# **Proposed modification to clause 150.5.1 PMD block diagram**

## **Figure 200-2-Block diagram for 400GBASE-SR4.2 transmit/receive paths**

***Rick Pimpinella***  
***Panduit Corporation***

IEEE P802.3cm 400 Gb/s over Multimode Fiber Task Force  
Vancouver, March 2019

Figure 200-2—Block diagram for 400GBASE-SR4.2 transmit/receive paths

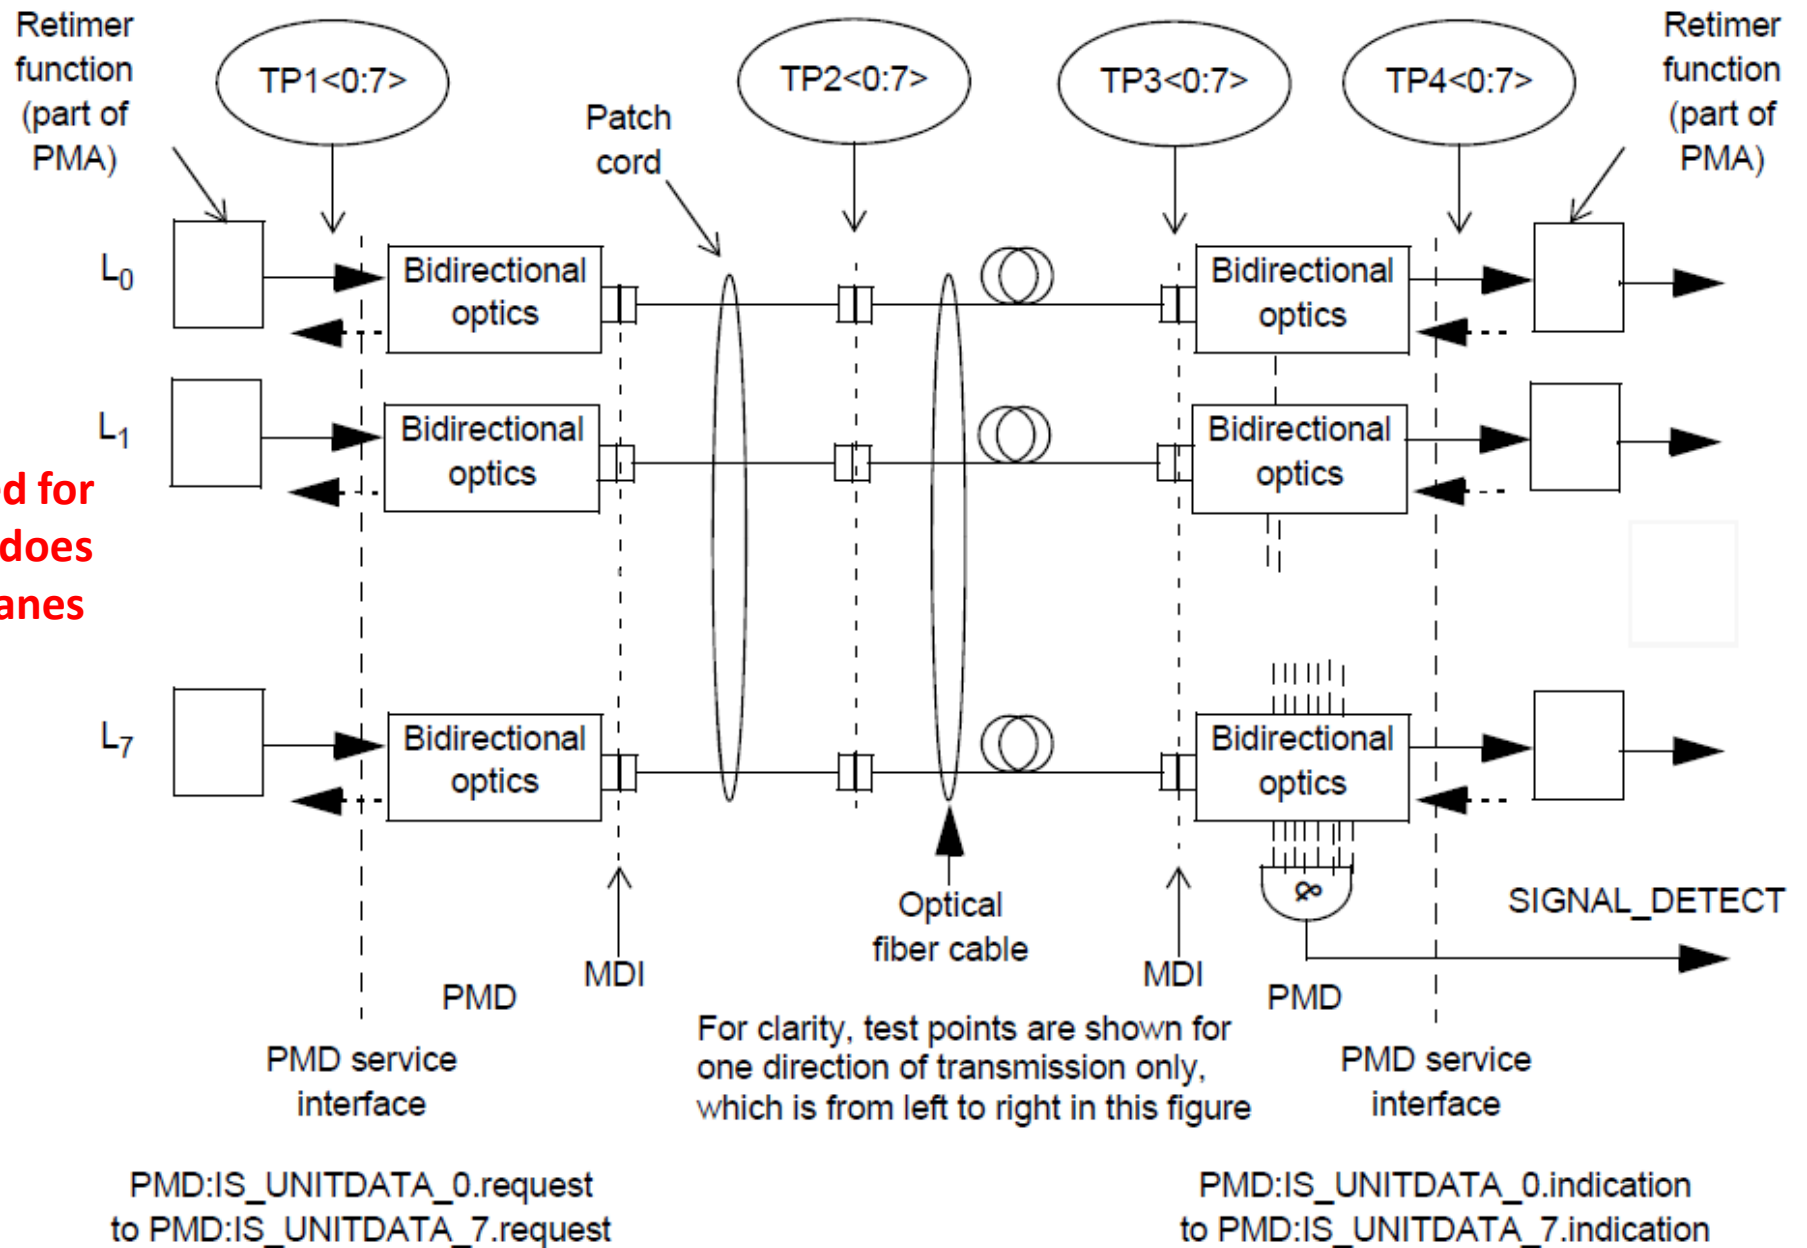
This figure is under specified for bidirectional transmission, does not relate wavelengths to lanes
